**REPORT ON INDEPENDENT  
ANALYSIS AND ADVICE  
REGARDING THE SAFETY CASE  
ADDENDUM**

# **Tihange 2**

## **Reactor Pressure Vessel Assessment**

**Figure 2.1: Size of the largest flaws with 20° inclination potentially not reported by UT inspection**

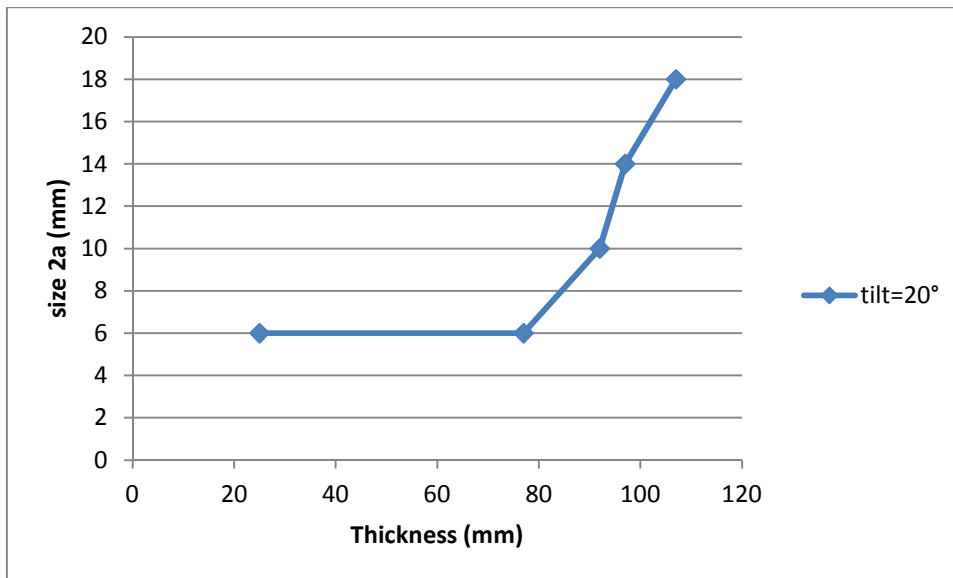
The Safety Authorities requested the performance of a sensitivity study of mechanical integrity. An envelope curve for the size of a potentially unreported flaw was determined in order to obtain a realistic basis to add potentially unreported flaws. Based on that input, the Project Team simulated various flaw configurations (orientation, size, tilt). The curve below represents the maximum size of a potentially unreported flaw with a conservative 20° tilt. This is the main input for the sensitivity analysis (see Chapter 5.3).

- The calculation of an envelope curve to define the size of the largest flaws with respect to the depth inside the material that would potentially not have been reported (see Figure 2.1). This relies on a deterministic approach and does not need to be penalized again.
- The use of a statistical and probabilistic tool in order to define the distribution of the additional postulated flaws.
